10.4 Other Features of Steam and Power Conversion

The information in this section of the reference ABWR DCD, including all subsections, tables, and figures is incorporated by reference with the following departures and supplements.

Figure 10.4-7 LP Extraction Steam Drains and Vent System

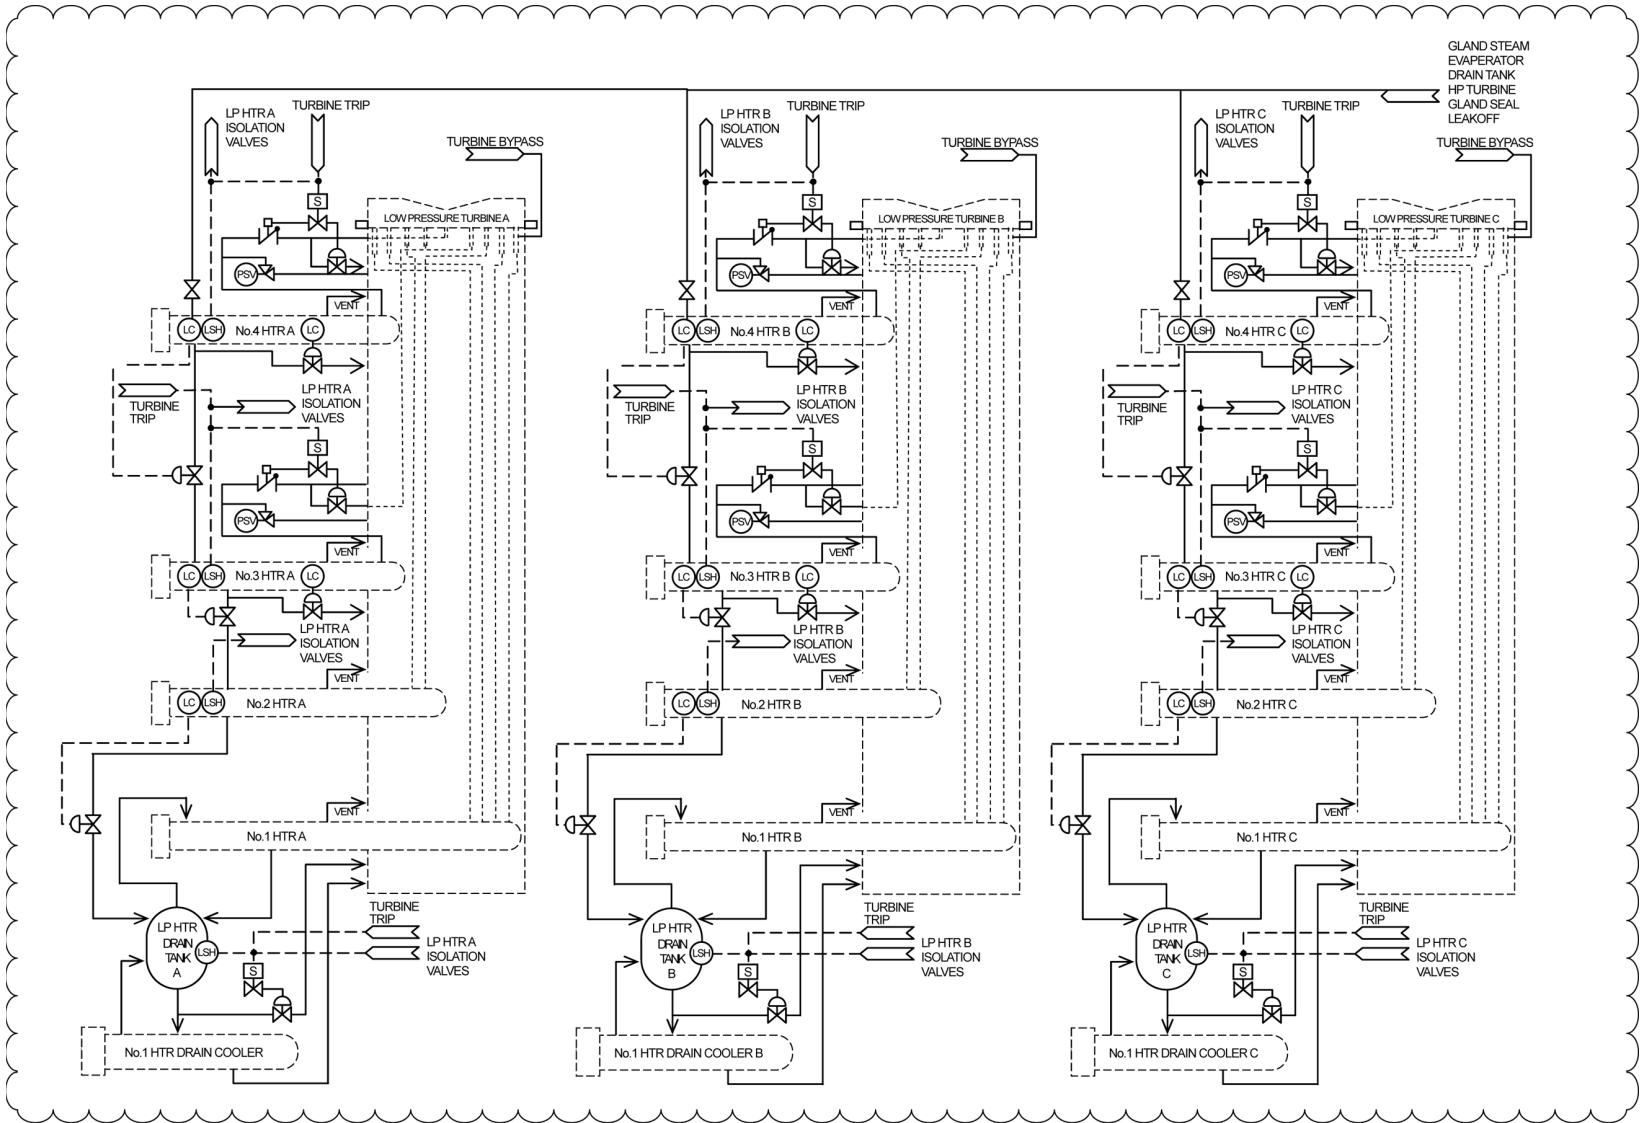
STD DEP 10.4-5 (Tables 10.4-4, 10.4-5 and 10.4-6, Figures 10.4-5, 10.4-6, 10.4-7, and 10.4-8)

The Condensate and Feedwater System (Figures 10.4-5 and 10.4-6) consists of the piping, valves, pumps, heat exchangers, controls and instrumentation, and the associated equipment and subsystems which supply the reactor with heated feedwater in a closed steam cycle utilizing regenerative feedwater heating. The system described in this subsection extends from the main condenser outlet to (but not including) the seismic interface restraint outside of containment. The remainder of the system, extending from the restraint to the reactor, is described in Chapter 5. Turbine cycle steam is utilized for a total of six stages of closed feedwater heating. The drains from each stage of the low-pressure feedwater heaters are cascaded through successively lower pressure feedwater heaters except the lowest and second lowest pressure feedwater heaters which drain to the low pressure heater drain tanks for each string. The drains from each low pressure heater drain tank flow into the external drain coolers of each lowest pressure feedwater heater and finally to the main condenser. The high pressure heater drains are pumped backward to the reactor feedwater pumps suction. The cycle extraction steam, drains and vents systems are illustrated in Figures 10.4-7 and 10.4-8.

Figure 10.4-9 Bypass Valve Control, Electro-Hydraulic Control Unit

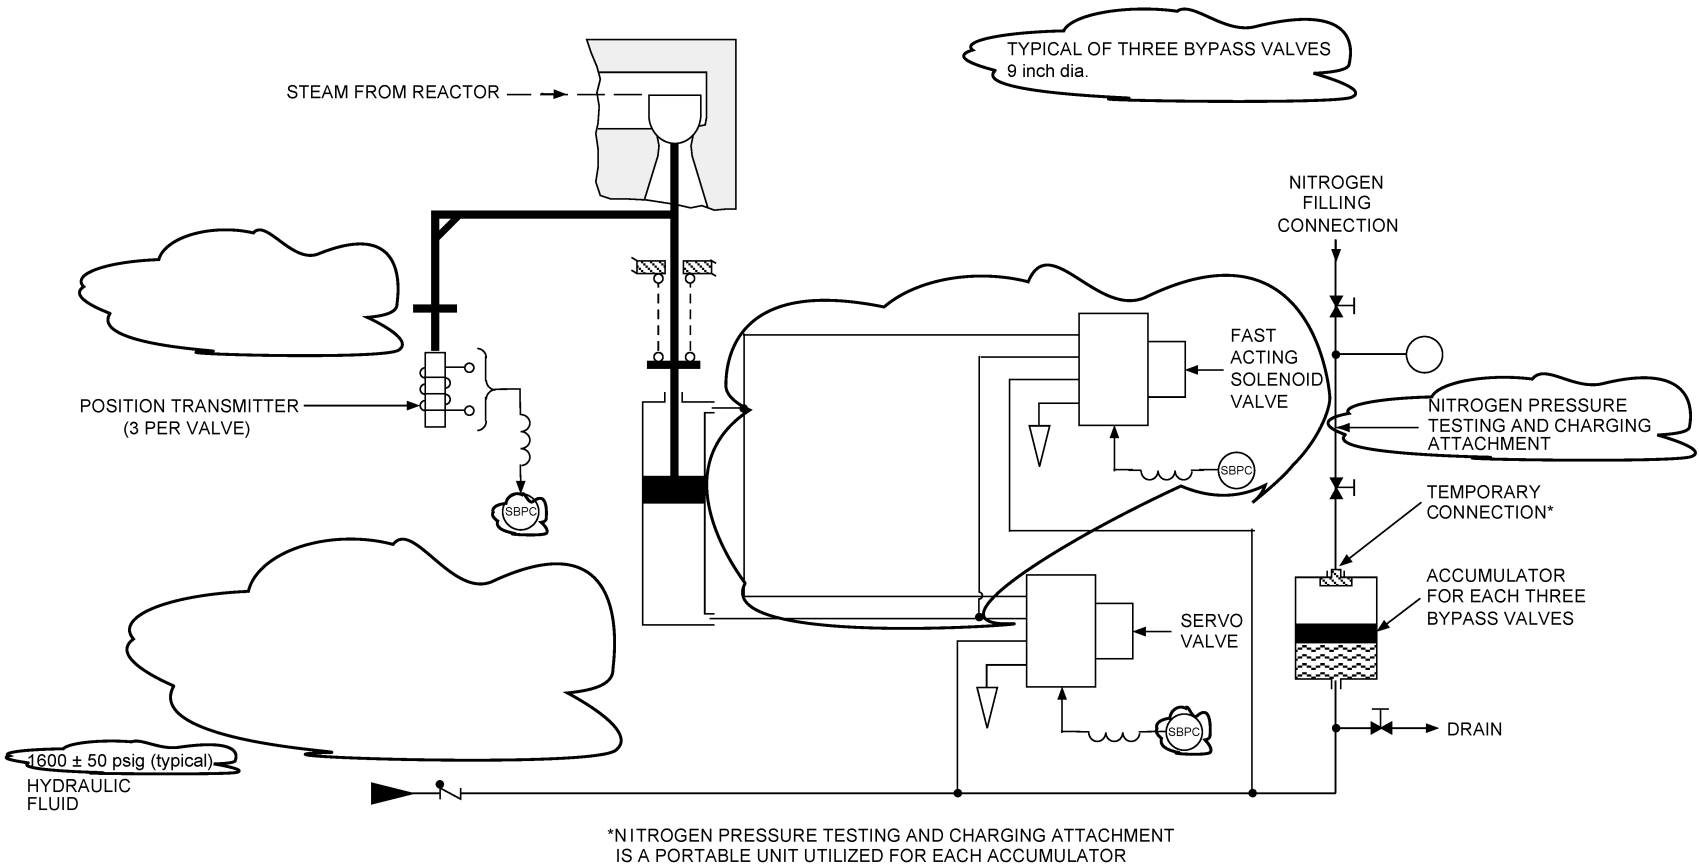
STD DEP 10.4-7 (Figure 10.4-9)
